DATE: January 4, 1971

TO: Owners and Operators of Yankee Aircraft

SUBJECT: Nose Gear Strut Inspection

MODELS AFFECTED: AA1-0001 thru AA1-0432. All spares stock of P/N 702057-501 and 702057-503 strut assemblies shipped from the factory before July 1, 1970.

FIGURE 1. Assembly of Test Fixture

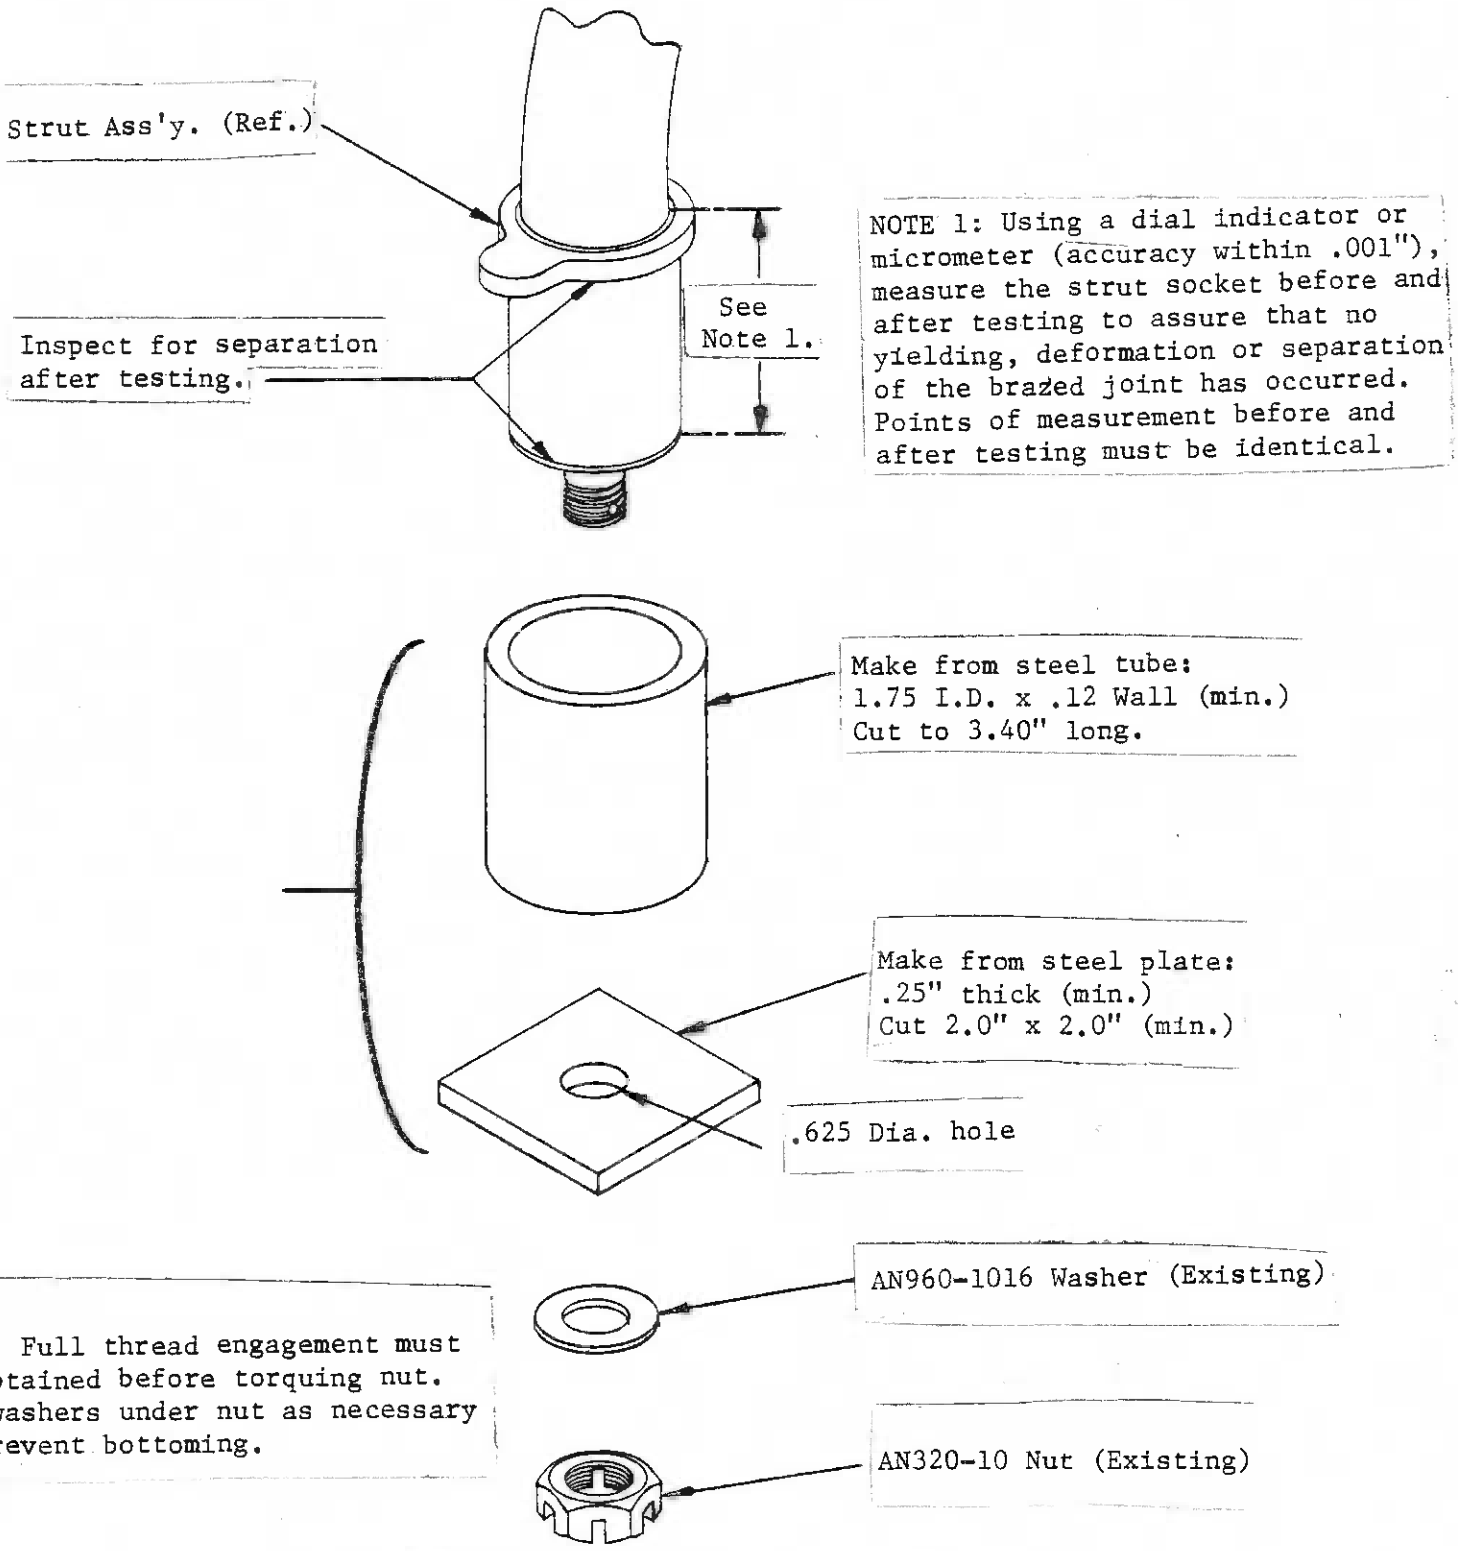
Field reports indicate the nose gear strut socket assembly may be defective in the area of the brazed joints. To confirm the structural integrity of the strut assembly, the following inspection and testing procedure must be followed within 10 hours of operation or sooner at the owner's discretion.

NOTE: A test fixture as shown in Figure 1 may be fabricated locally. One fixture, tool no. ST1086-501, will be forwarded to each dealer by January 9, 1971 at no charge.

1. Remove the nose gear fork assembly and "O" ring noting sequence of assembly of washers. Do not misplace thrust washer located between strut socket and fork. See Note 1, Figure 1.
2. Install test fixture as illustrated. Torque nut to 550 to 600 in. lbs. (46 to 50 ft. lbs.).

NOTE: The fork is installed using an AN960-1016 washer. This washer must be used between the fixture plate and nut as shown. Lubricate strut threads, washer and nut with engine oil prior to assembly.

3. Remove test fixture and inspect the strut socket assembly brazed joints as shown in Figure 1. If there is any evidence of difference in measurement before and after test, the strut must be replaced. See Note 1, Figure 1.
4. To insure that drain hole in bottom of strut is unobstructed, insert a .12" dia. drill at least 2.0 inches into hole.
5. Reinstall "O" ring, lubricate strut socket, fork bearing and washers with MIL-G-7711 grease or equivalent and install fork assembly and attaching hardware exactly as removed (Ref. Service Manual page 4-3).
6. Tighten nut until a 10-13 lb. force along axle center line is required to rotate fork. Install cotter pin and recheck force required to rotate fork.
7. Make entry in aircraft log book stating Service Bulletin No. 121 complied with. Complete and mail attached Service Reply Card.
